# THE VILLAS AT CLAREMONT RANCH

### STREET IMPROVEMENTS PLANS

SF-22-028

## STORM SEWER PLANS

**THE VILLAS AT CLAREMONT RANCH**  
**STORM SEWER PLAN & PROFILES**

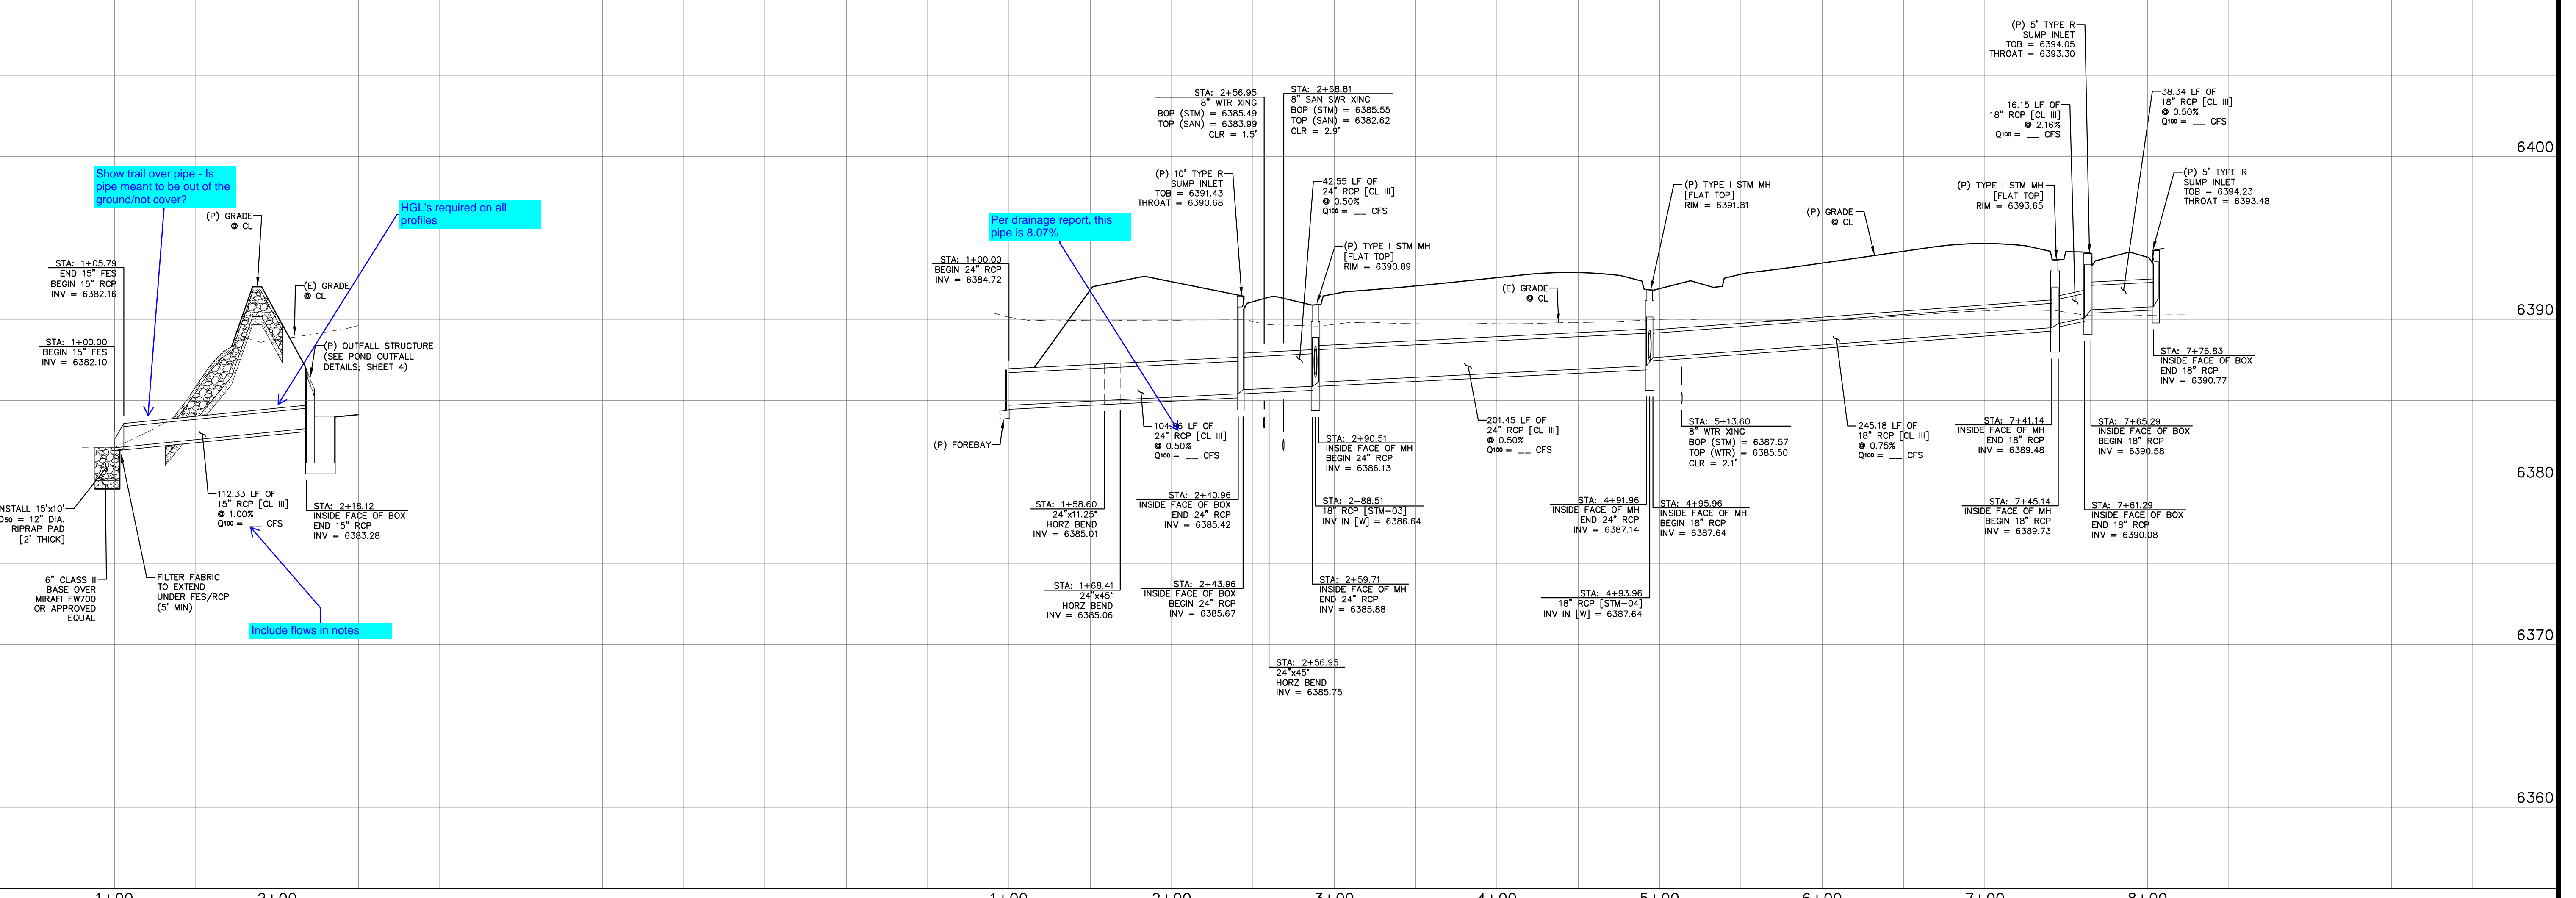
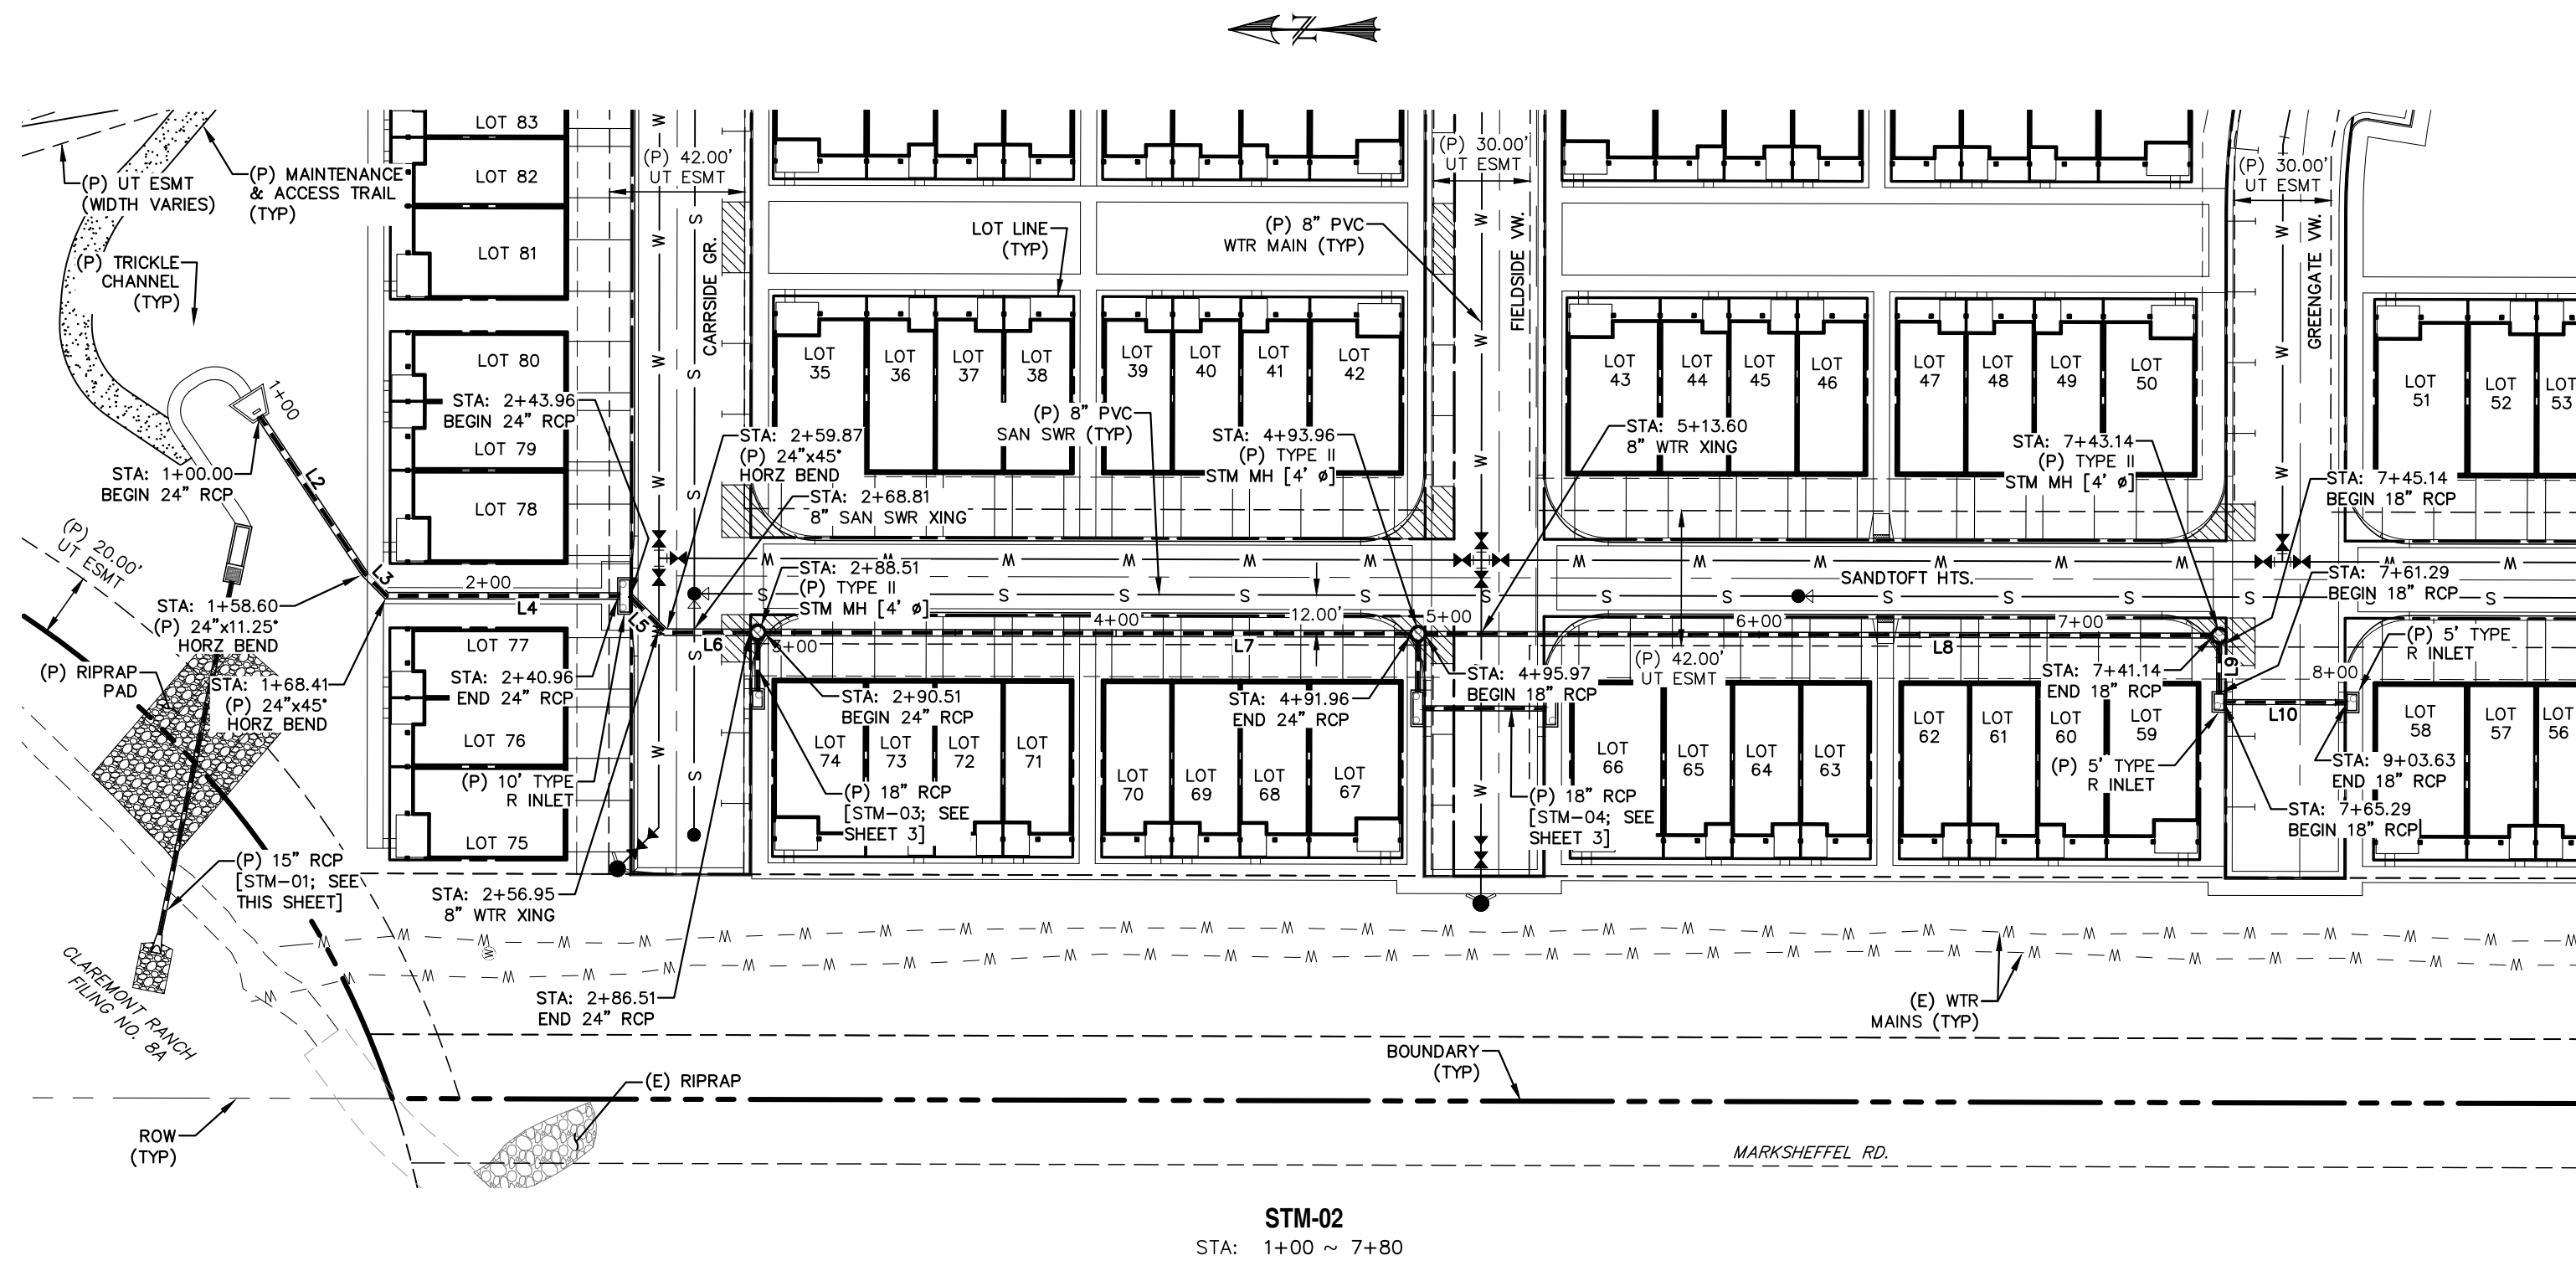
Show trail over pipe - Is pipe meant to be out of the ground/not cover?

HGL's required on all profiles

Per drainage report, this pipe is @ 0.7%

Include flows in notes

**THE VILLAS AT CLAREMONT RANCH**  
STORM SEWER PLAN & PROFILES

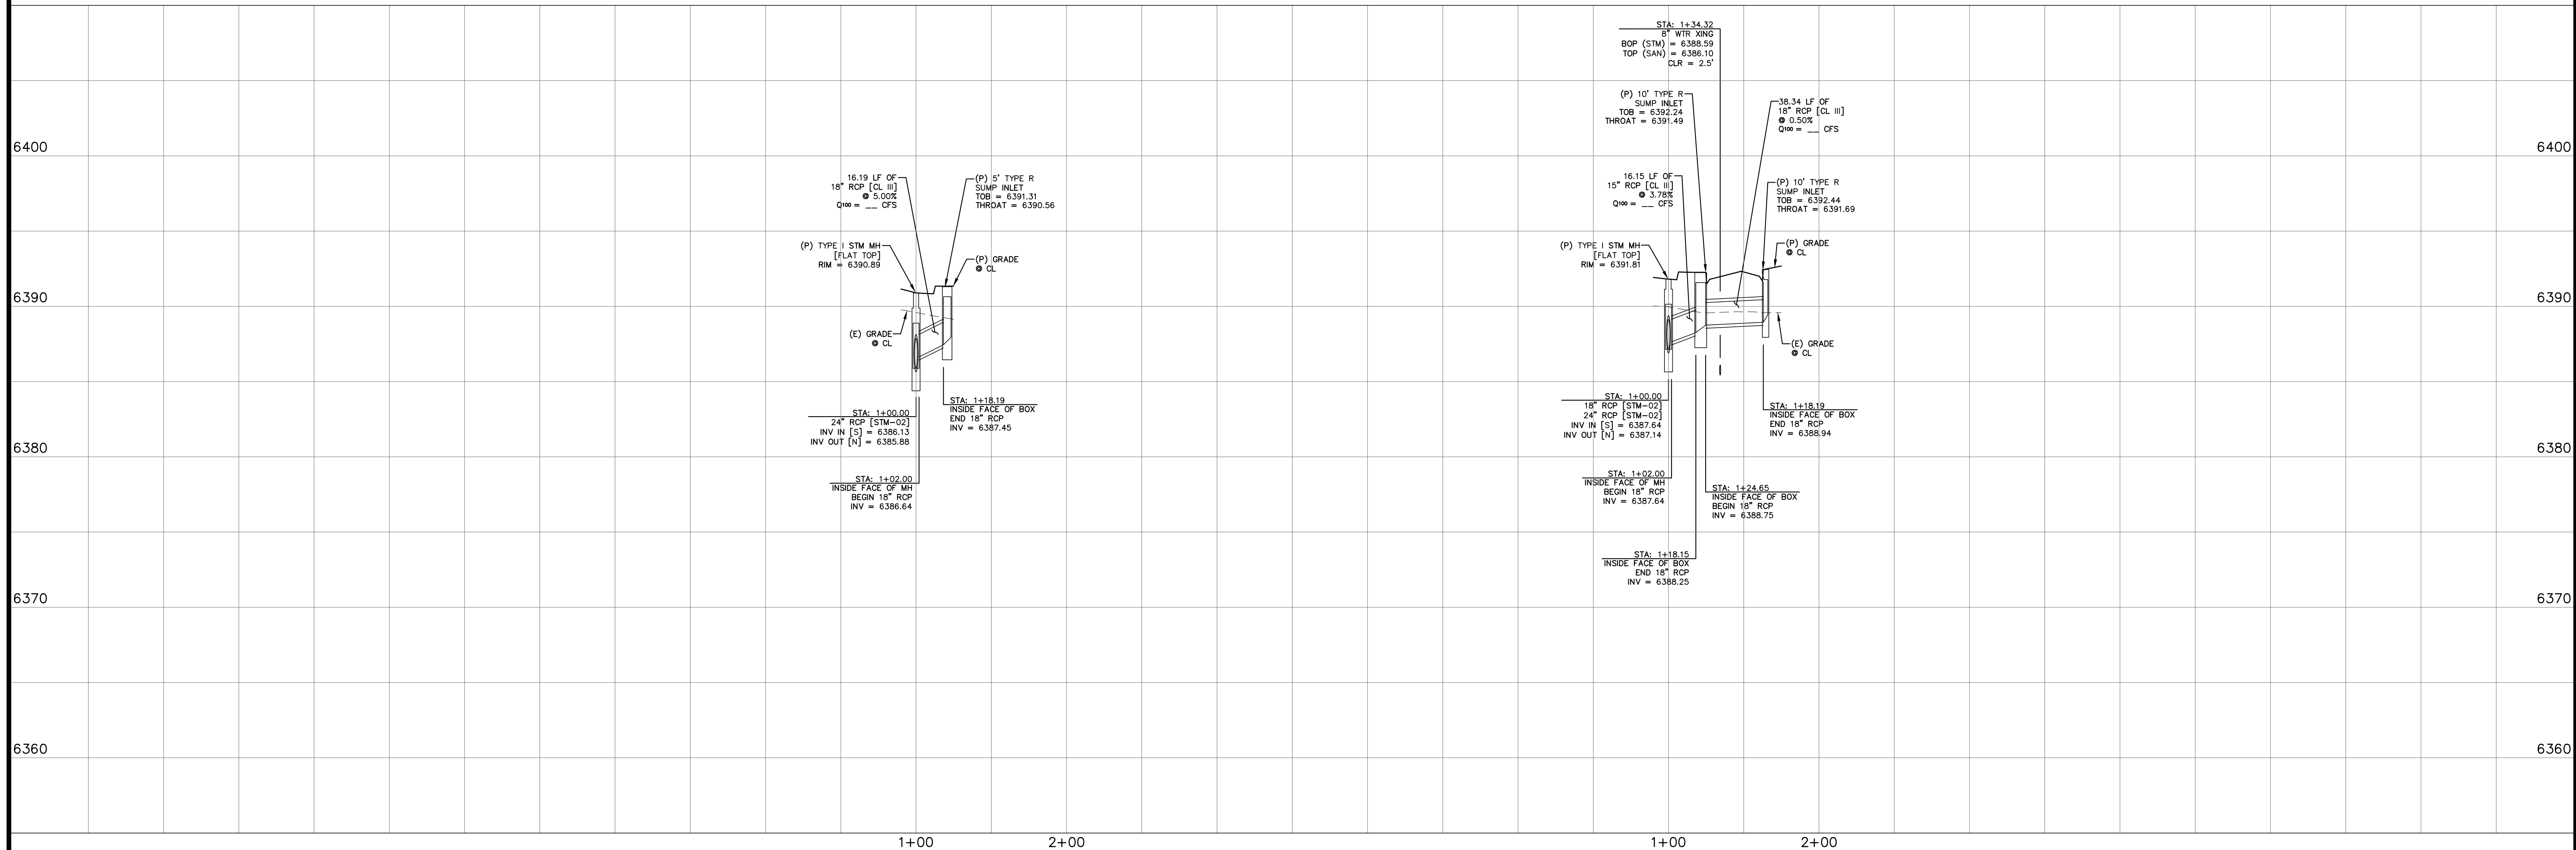
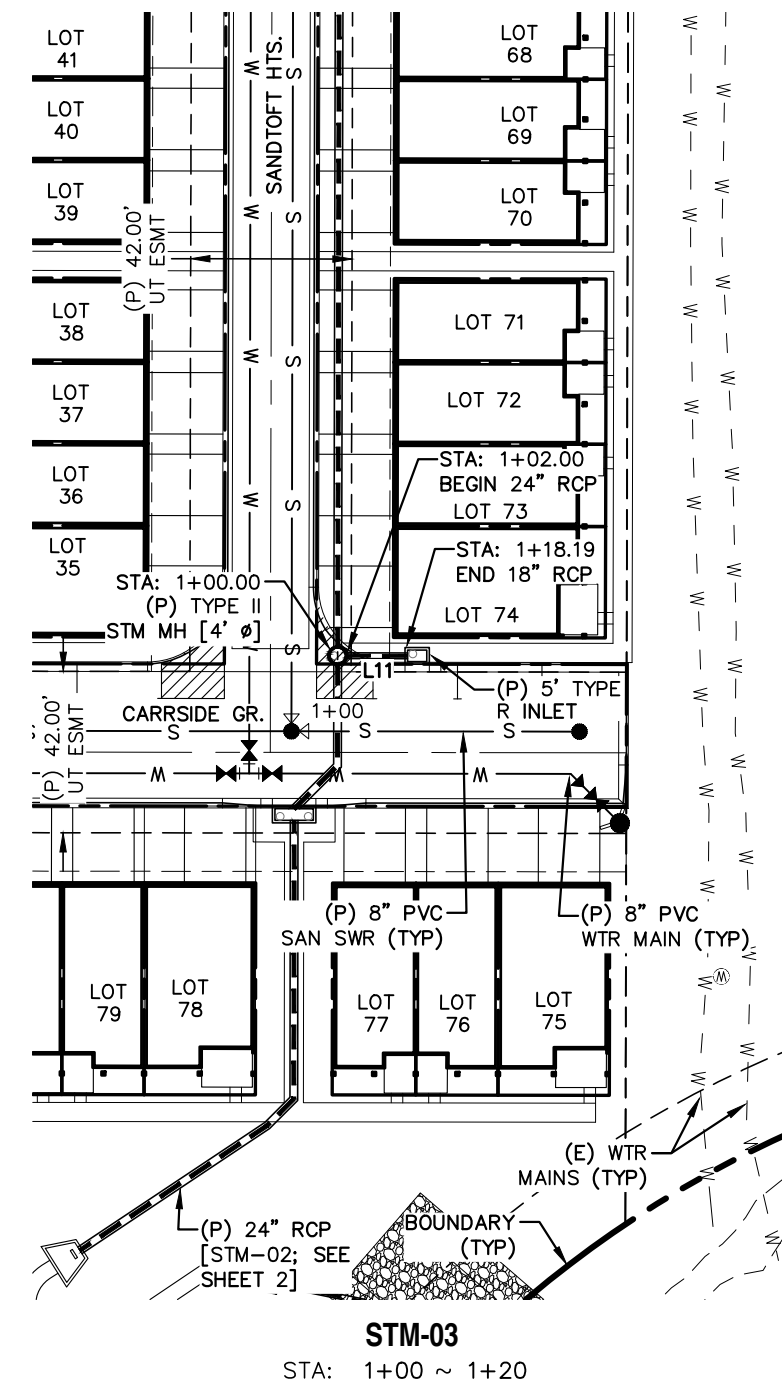
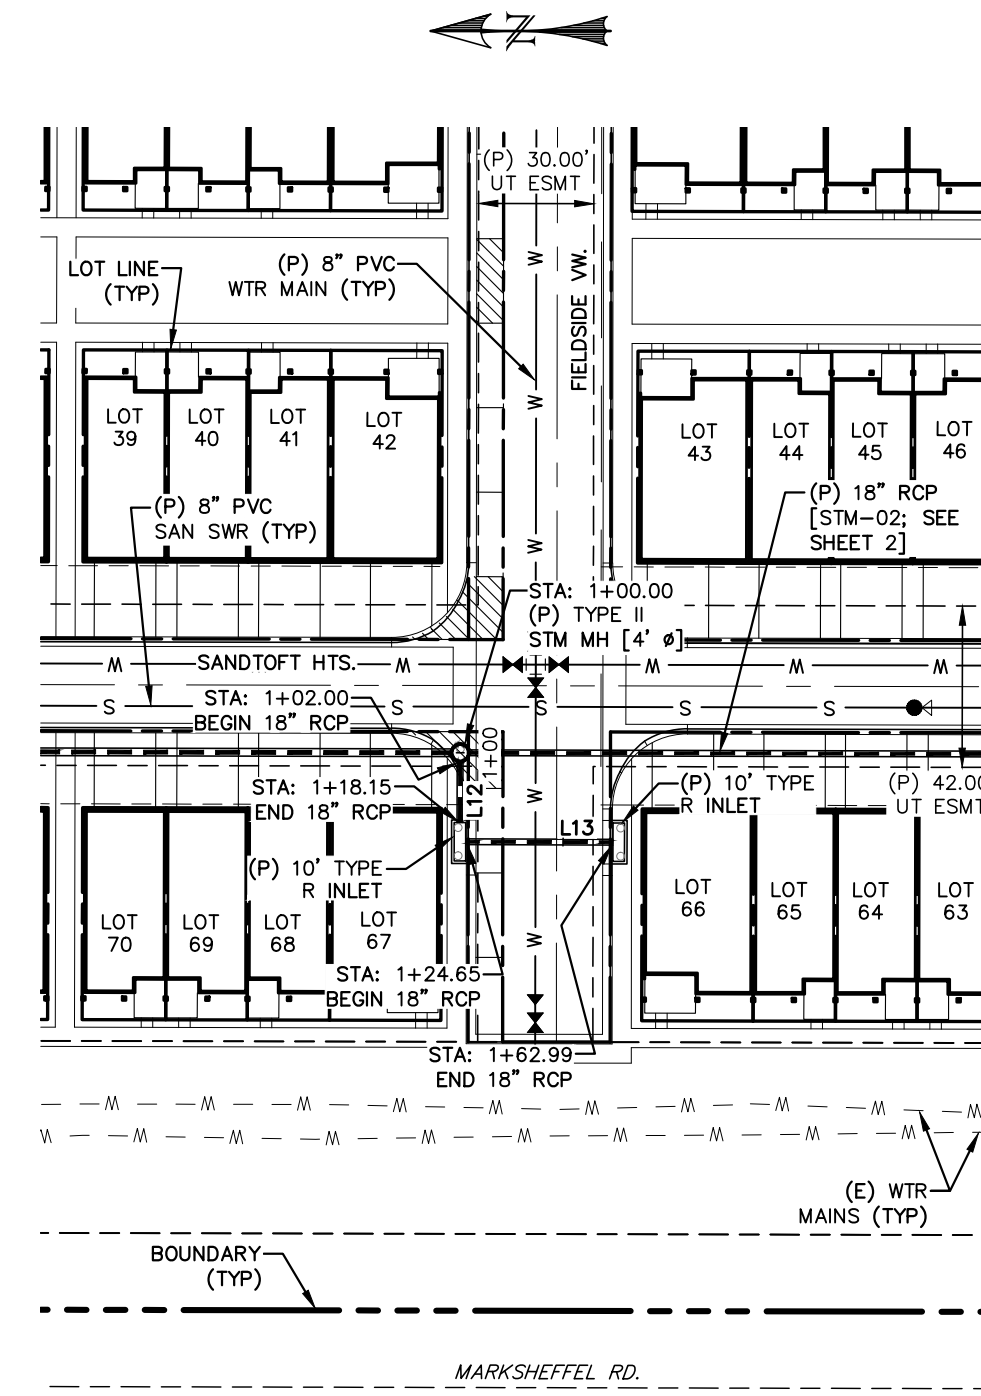
Provide storm details for manholes, inlets, riprap outlet protection
